HOPE CREEK GENERATING STATION
DOCKET NO. 50-354
DRAFT SAFETY EVALUATION REPORT
OPEN ITEM STATUS

Attachment 1 is a current list which provides a status of the open items identified in Section 1.7 of the Draft Safety Evaluation Report (SER). Items identified as "complete" are those for which PSE&G has provided responses and no confirmation of status has been received from the staff. We will consider these items closed unless notified otherwise. In order to permit timely resolution of items identified as "complete" which may not be resolved to the staff's satisfaction, please provide a specific description of the issue which remains to be resolved.

In addition, enclosed for your review and approval (see Attachment 4) are the resolutions to the Draft SER open items and the resolution of comments received during the April 17 and 18, 1984, Power Systems Branch (Mechanical) meeting on the 430 questions series, listed in Attachment 3. A signed original of the required affidavit is provided to document the submittal of these DSER open item and FSAR question responses.

NEW SHEET 1

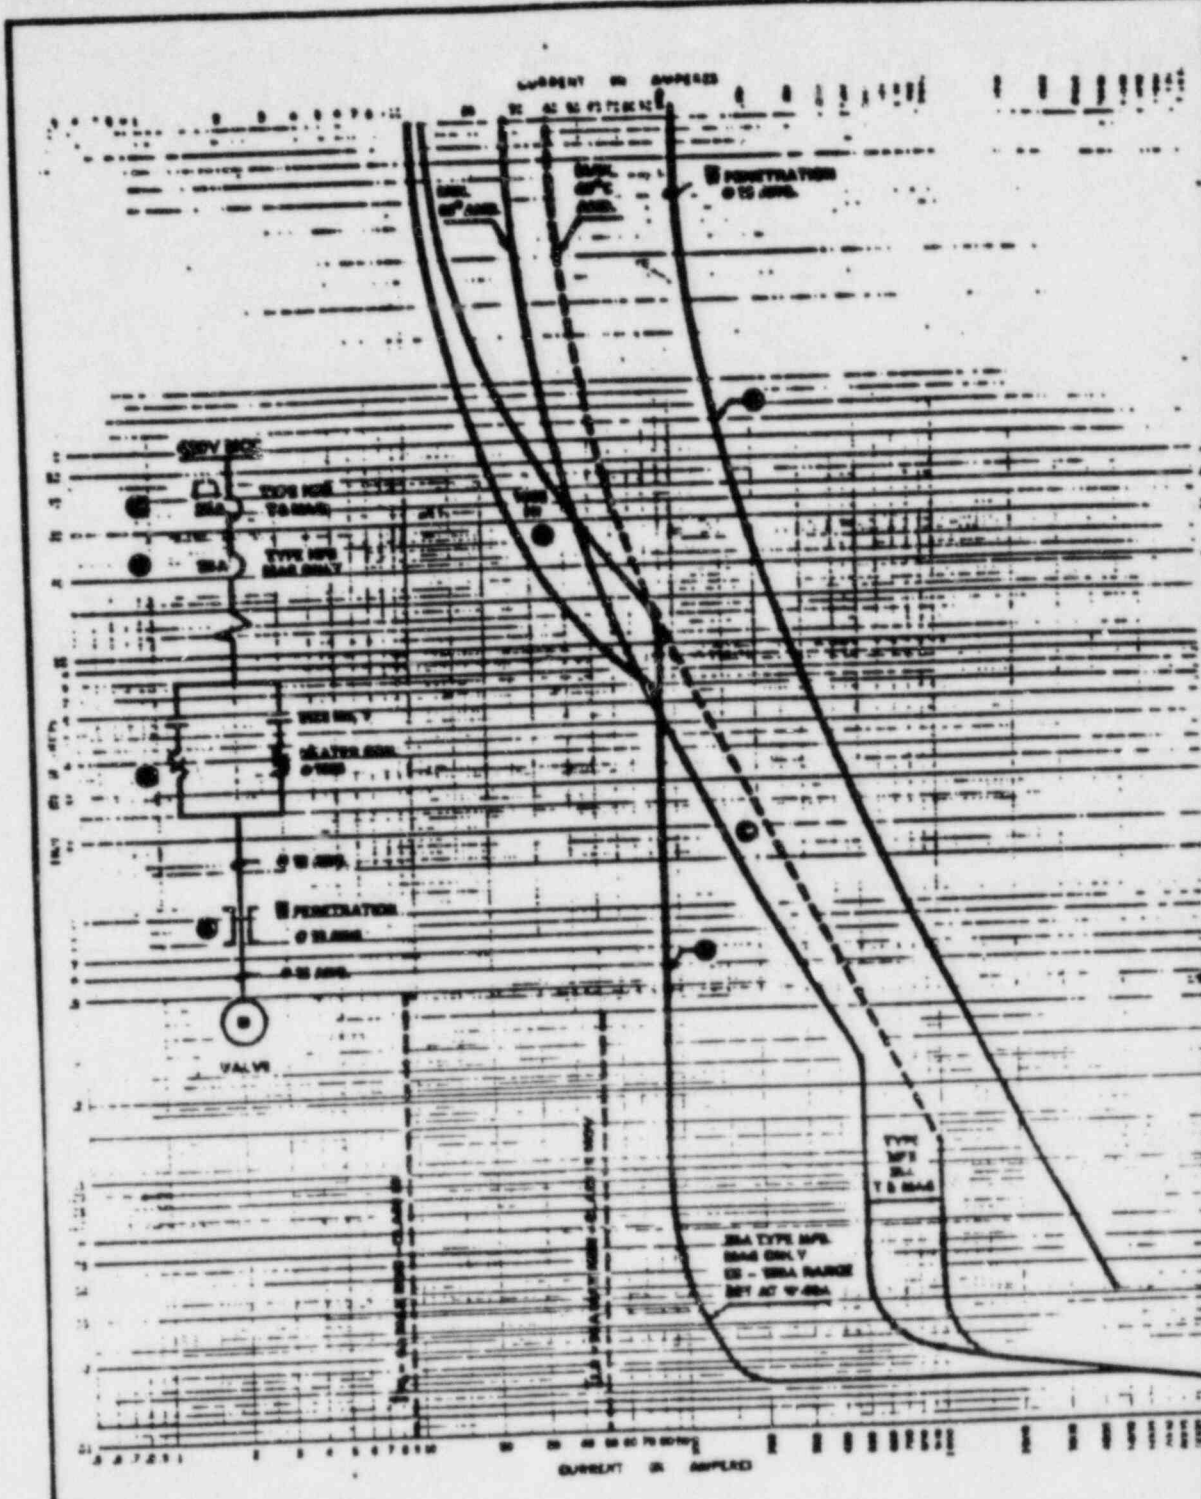
THIS SHEET IS BEING SUPERCEDED
BY SHEETS 1 & 2. THE REVISED SHEET 1
SHOWS THE CURVES FOR NON-CLASS IE
VALVES & THE NEW SHEET 2 SHOWS
THE CURVES FOR CLASS IE MOV'S.
SEE ATTACHED SHEETS 1 & 2
REPLACED BY SHEETS 1 and 2 of 20.
(ATTACHED)

REVISED FIGURE 430.46 SHEETS 2, 4, 6, AND 8 SHOW THAT FOR A CLASS 1E MOV, THE THERMAL OVERLOAD IS BYPASSED AND IS NOT RELIED ON TO PROVIDE PROTECTION FOR THE ELECTRICAL PENETRATION. THE PRIMARY AND BACKUP PROTECTION FOR THE ELECTRICAL PENETRATION IS PROVIDED BY MAGNETIC ONLY AND THERMAL-MAGNETIC CIRCUIT BREAKERS RESPECTIVELY.

REPLACED BY NEW SHEETS 7 & 8.
 (ATTACHED)

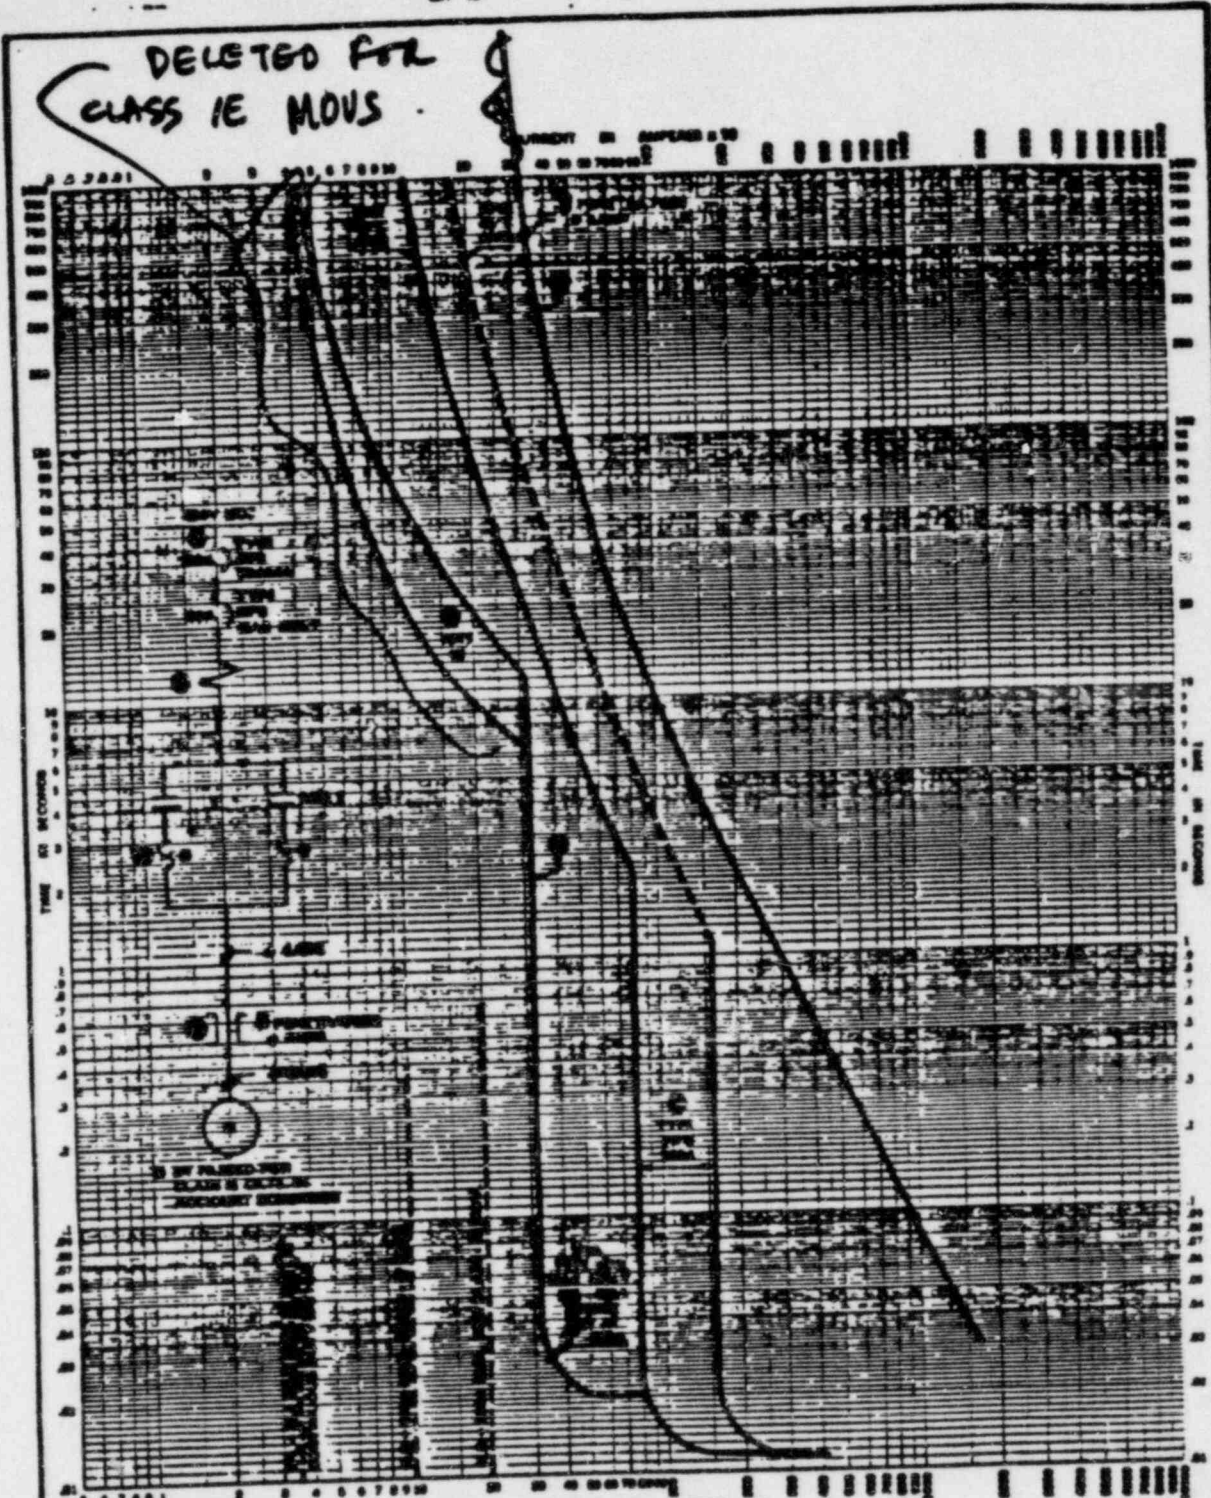
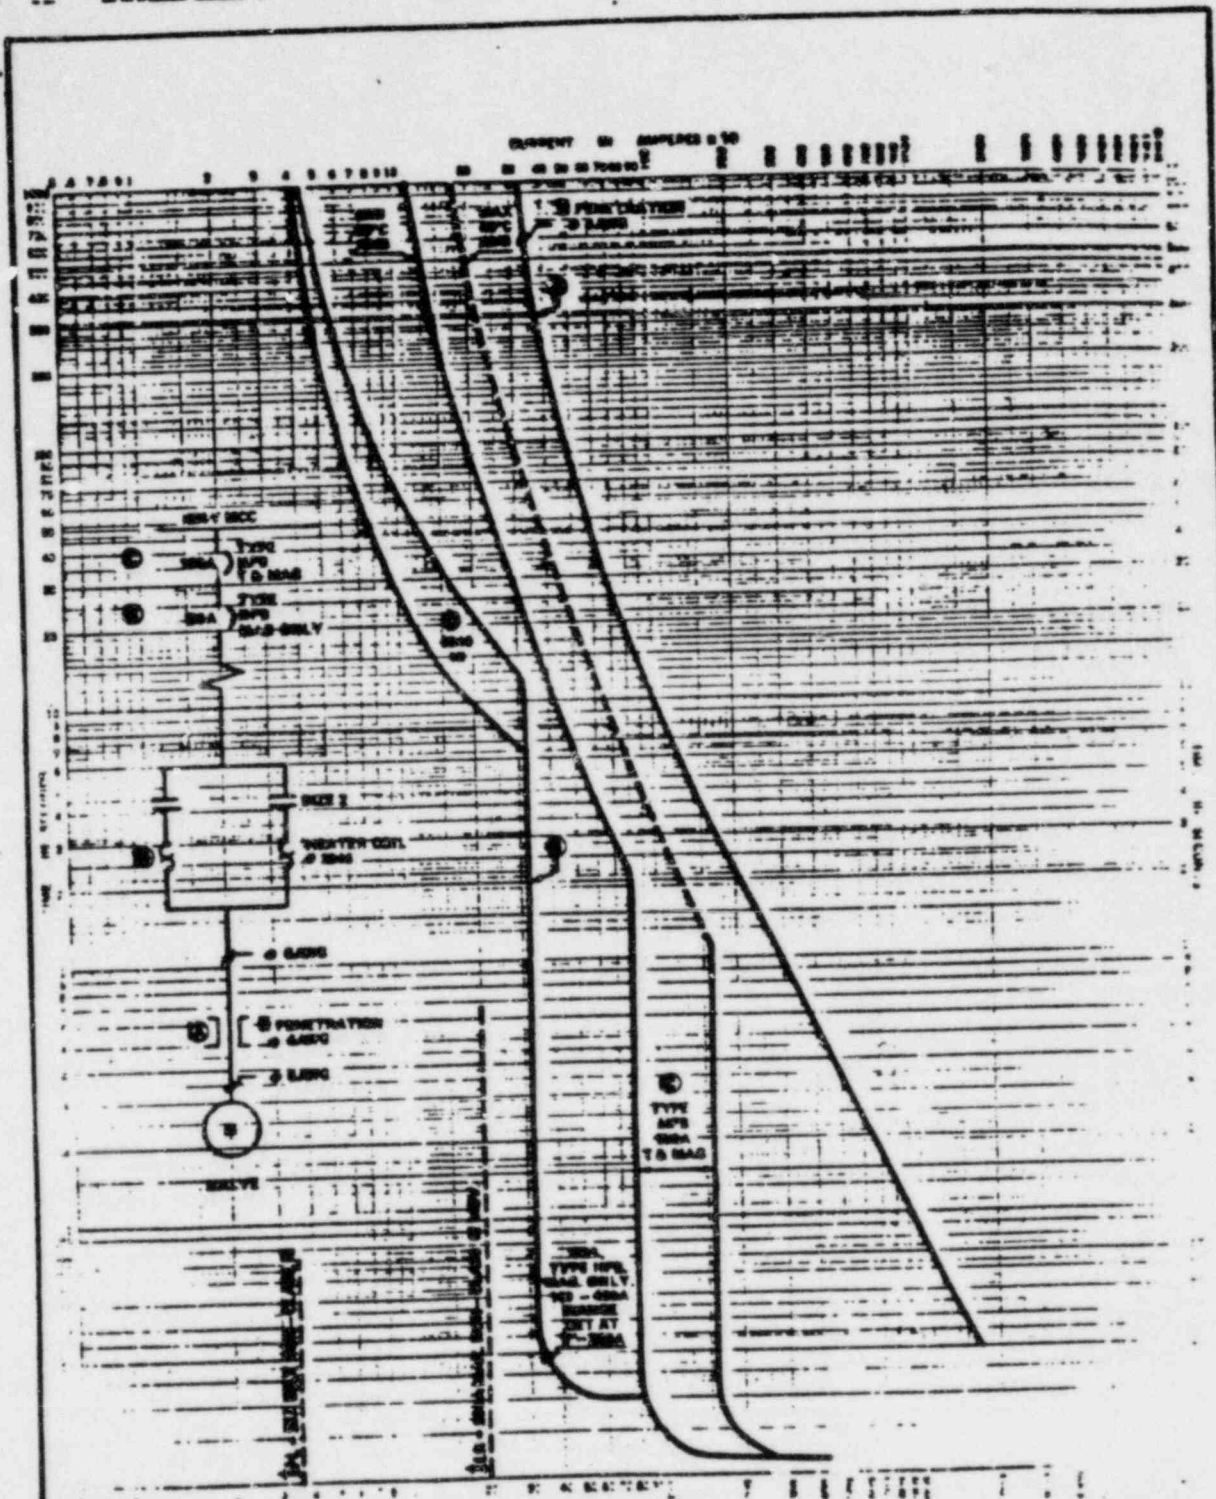
THIS SHEET IS SUPERCEDED BY NEW SHEETS 7 & 8.
 THE NEW SHEET 7 SHOWS THE COORDINATION
 CURVES FOR NON-CLASS IE MOV & THE NEW
 SHEET 8 SHOWS THE COORDINATION CURVE
 FOR CLASS IE MOV.
